**TOWN OF FAIRFAX
STAFF REPORT
Department of Planning and Building Services**

TO: Fairfax Planning Commission
DATE: May 19, 2016
FROM: Jim Moore, Director of Planning and Building Services
Linda Neal, Principal Planner
LOCATION: 22 Meadow Way; Assessor' Parcel No. 003-122-50
ZONING: Residential Single-family RS 6 Zone
PROJECT: 50% remodel/expansion of a single-family residence
ACTION: Hill Area Residential Development Permit, Parking Variance,
Excavation Permit, Design Review Permit
APPLICANT: Rich Rushton, Rushton Chartock Architects
OWNER: Nadim and Stacy Nahas
CEQA STATUS: Categorically Exempt, § 15301(2)

22 MEADOW WAY

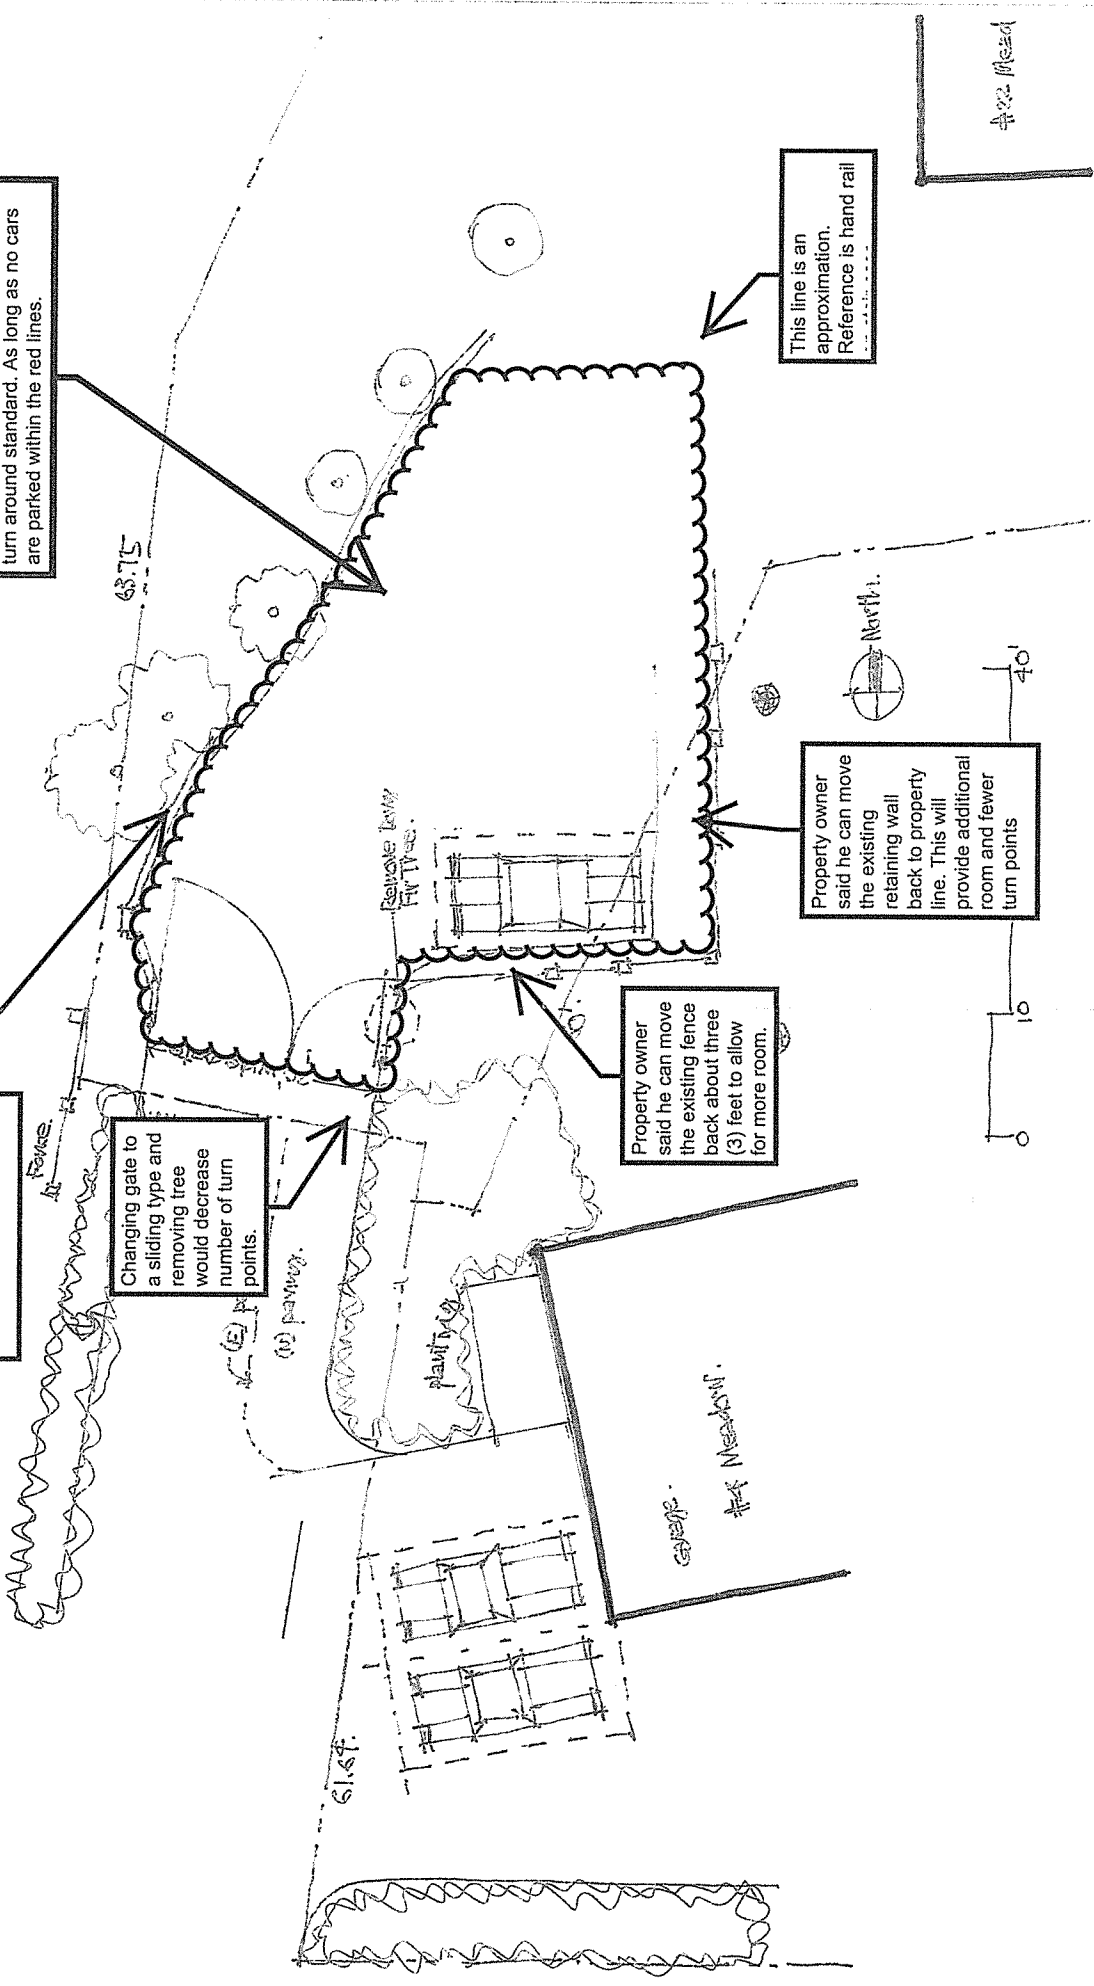
If utility pole and oak tree were removed it would allow for swing over edge of the road way

Changing gate to a sliding type and removing tree would decrease number of turn points.

Area can provide for an alternative to the turn around standard. As long as no cars are parked within the red lines.
